**BRUNSWICK-GLYNN JOINT
WATER & SEWER COMMISSION**
December 7, 2021

PROJECT: Request for Proposal No. 22-014 Engineering Services for Pump Station Upgrades – PS3101, PS4001, PS4002

ADDENDUM: Two (2)

PROJECT MAP

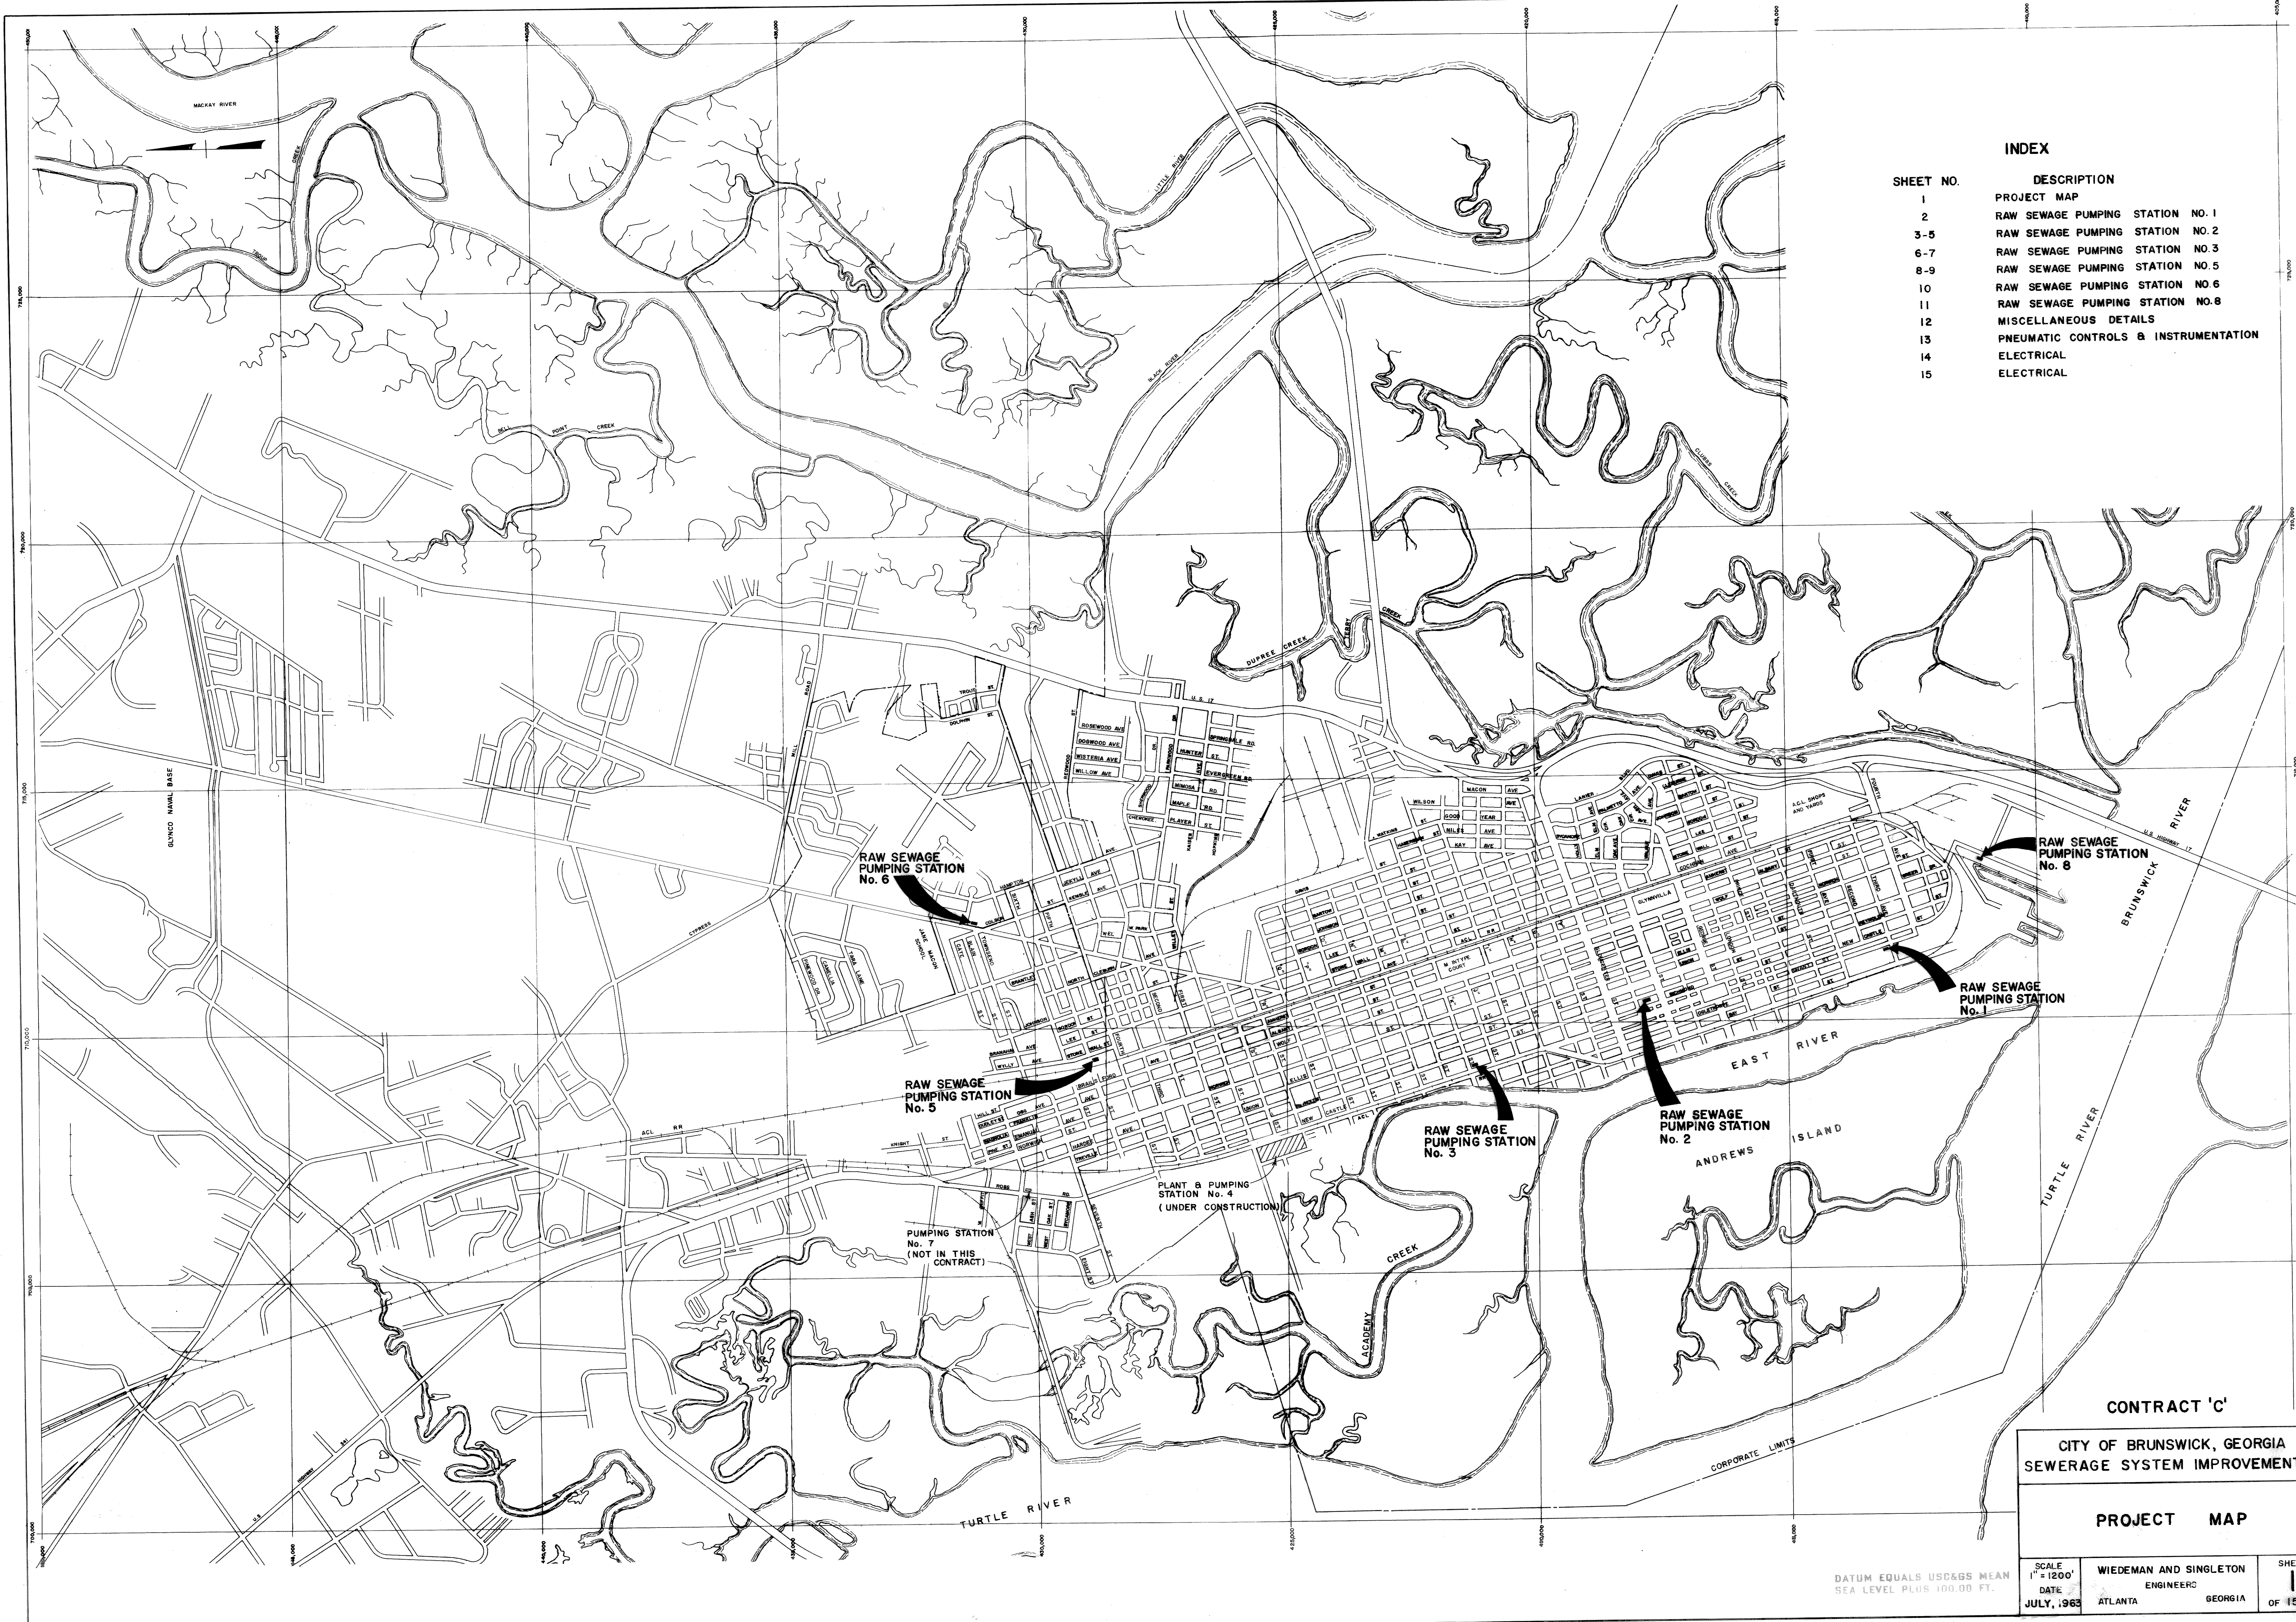
- 1) **QUESTION:** In review of the available drawings for each station provided at the Dropbox link, we found that the drawings in file “BRUNSWICK_1963 07_JULY_SPLINT_CONTRACT C Sheet 12-15” for both Pump Station 4001 and 4002 are identical. Is this correct?

ANSWER: The drawings for those two stations are in the same “set”. Sheets 12-15 were included on both stations so that firms are aware that the information provided pertains to both stations. The project map from the original drawings is attached here and posted to the website for clarification, <https://www.bgjwsc.org/request-for-proposals-no-22-014-engineering-services-for-pump-station-upgrades-for-ps3101-ps4001-and-ps4002/>
